Section I

I-Staff-1

Ref: S I-1/T1/S1/p. 1 and S VI/S1/p. 2

Table 18c

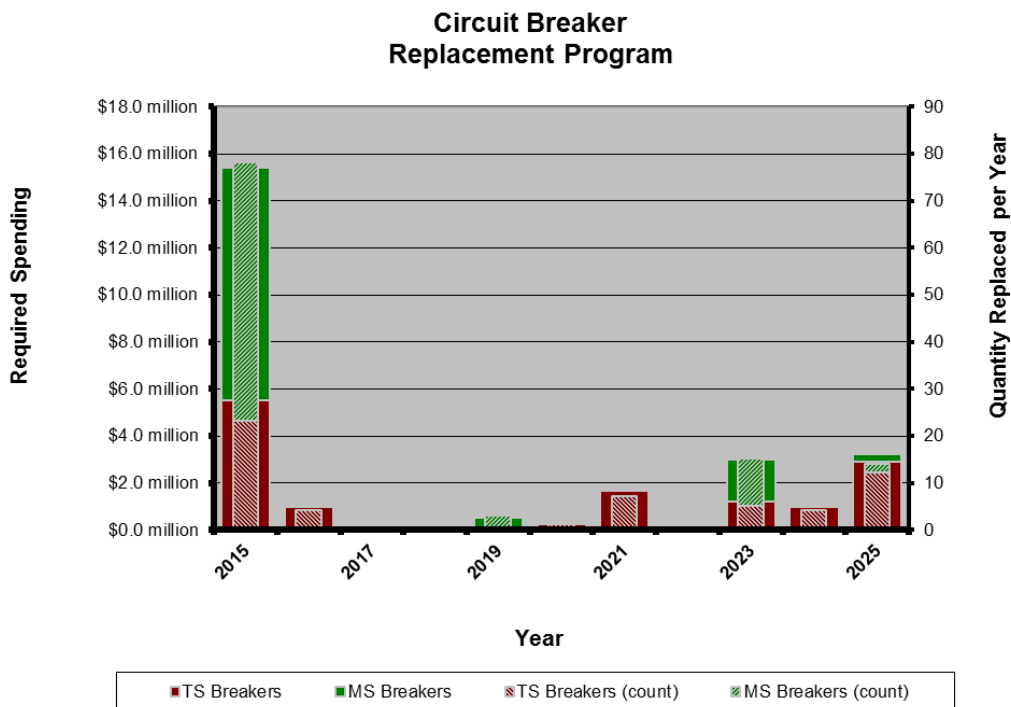
- c) What is the inspection year of the data used for the asset condition assessment? If variable between asset classes please provide what data is from which year. If varied between the units within the asset class, please provide a range of the earliest and latest inspection data used for the asset condition assessment for this asset class.

- b) All Asset Condition Assessment results presented in the section Asset Inventory are based on the asset registry and inspection data as of December 31, 2014.
- c) The inspection years of the data used for the asset condition assessment are shown in the Table 18c.

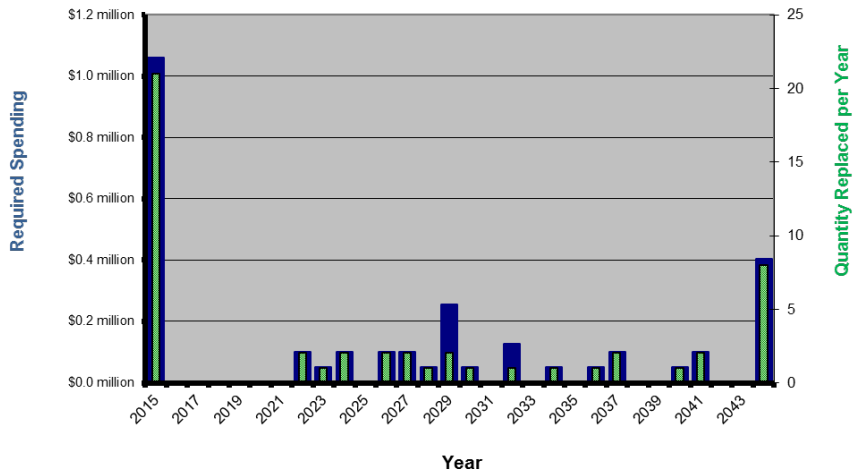
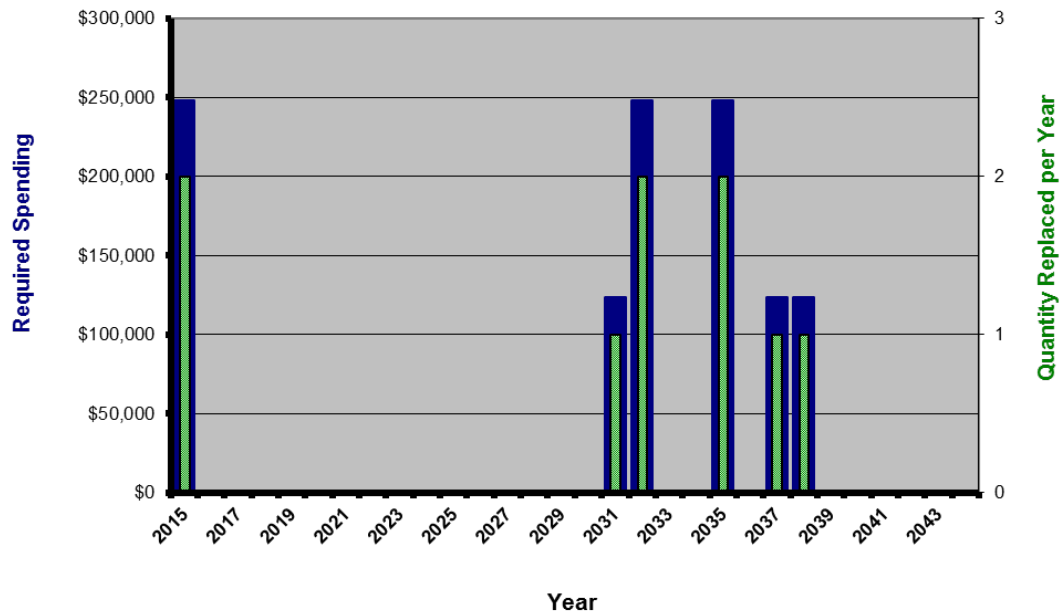
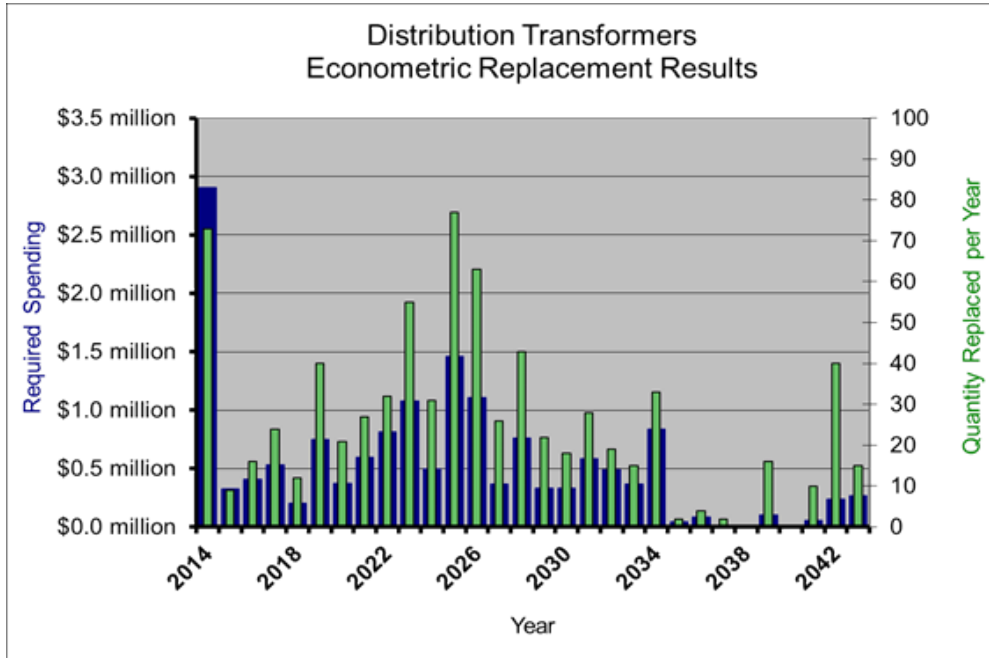
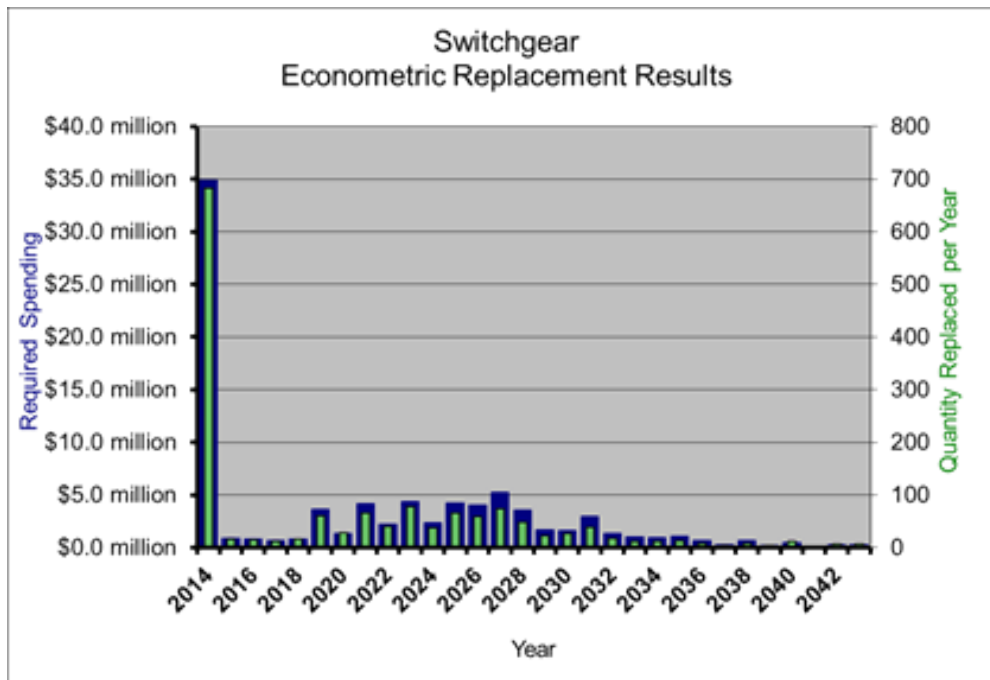
- d) Did PowerStream update Risk-based economic analysis and Econometric replacement results in accordance with the ACA report provided in EB-2013-0166? If yes, please provide the results. If no, please explain.

For these assets the ACA models do not have Econometric Replacement Results.
